Wednesday, November 2, 2022
PERMIT MODIFICATION APPROVAL
Horizontal 6A / New Drill

Re: Permit Modification Approval for CASH 1H
47-103-03398-00-00

Cement Variance to include the use of Class A / Class L cement

Re: Class L Cement Variance Request
Cash 1H Well
Permit Number 47-103-03398
Center District, Wetzel County

Wellbore Diagram

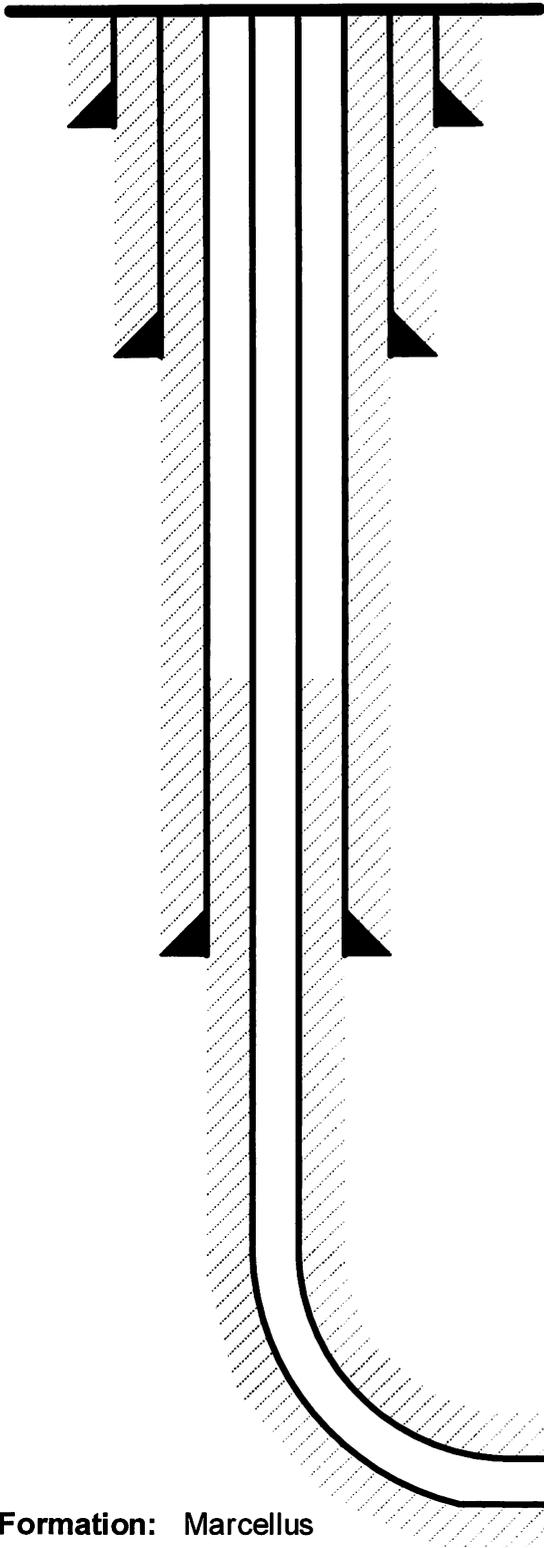
This modification is to add the potential use of Class L cement as an option for casing and cementing of this well.

26", 85.6#, A252 GR3, cement to surface w/ Class A/L

13-3/8", 54.5#, J-55, cement to surface w/ Class A/L

9-5/8", 36#, J-55, cement to surface w/ Class A/L

6", 24#, P-110, cement to 500' inside 9-5/8" w/ Class A/H/L
